# Potential Acquisition of Monterey Water System and District Boundary Adjustment

## Final Environmental Impact Report

**Monterey Peninsula Water Management District**

Figure 2-2 District and Project Boundaries

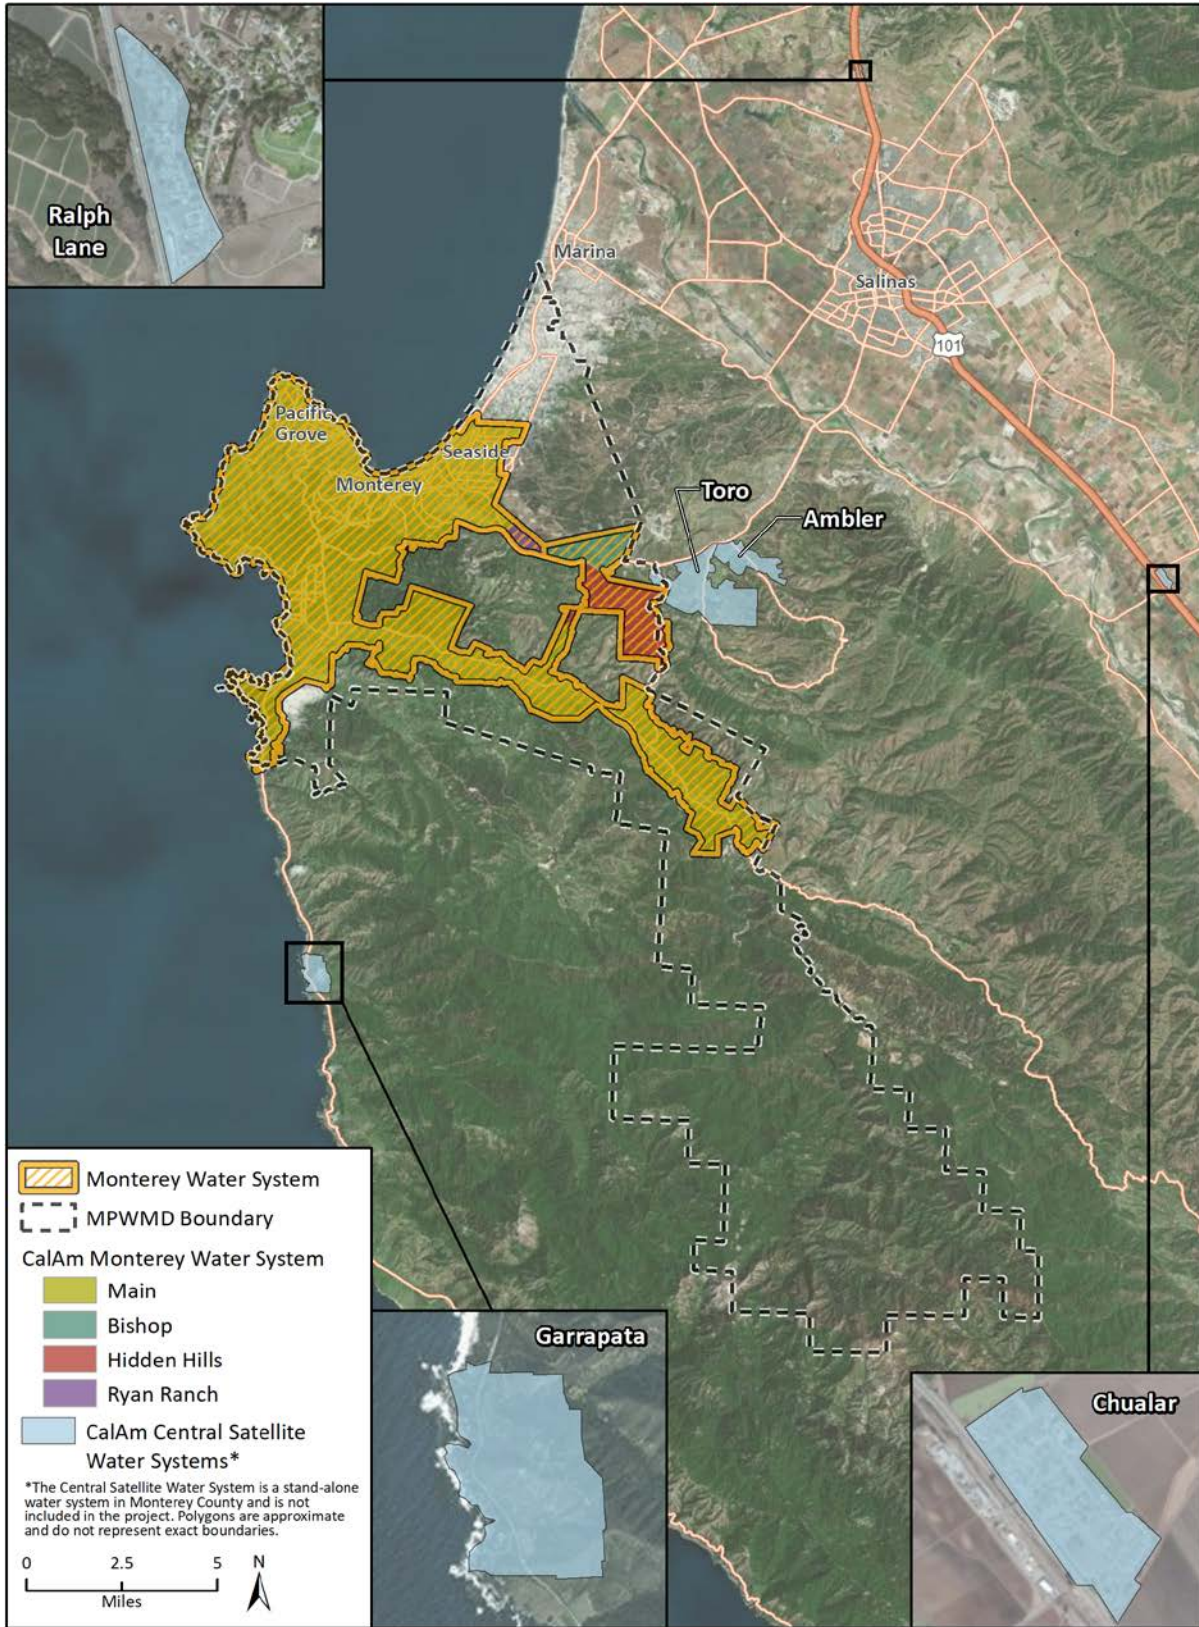
Although we do not live in your district, this document could potentially affect us. On page 2-3, Figure 2-2, which is entitled "District and Project Boundary" incorrectly shows the boundary for the Garrapata satellite system. A note in the legend box states that Polygons are approximate and do not represent exact boundaries, is inadequate since the very purpose of this document is to consider changing boundaries. Our property appears to be shown inside the polygon for the Garrapata satellite system. We are upstream of that system and have always been outside the water company's service area, as well as outside your district's boundary. We further understand that satellite systems such as Garrapata are not included in the acquisition but since they are operated by CalAm, it is hard to see that they would not in some way be impacted, since they use common personnel, equipment and facilities.

The commenter notes the project site boundary in Figure 2-2 is inaccurate and includes their facility and asks that the figure be revised to reflect the project boundaries more accurately.

Figure 2-2 shows the most up-to-date service area boundaries for CalAm as identified in the 2015 UWMP (see Figure 3-1 in the 2015 UWMP) and shows the abandoned trout farm within the Garrapata System. As such, the figure is correct and has not been updated in response to this comment.
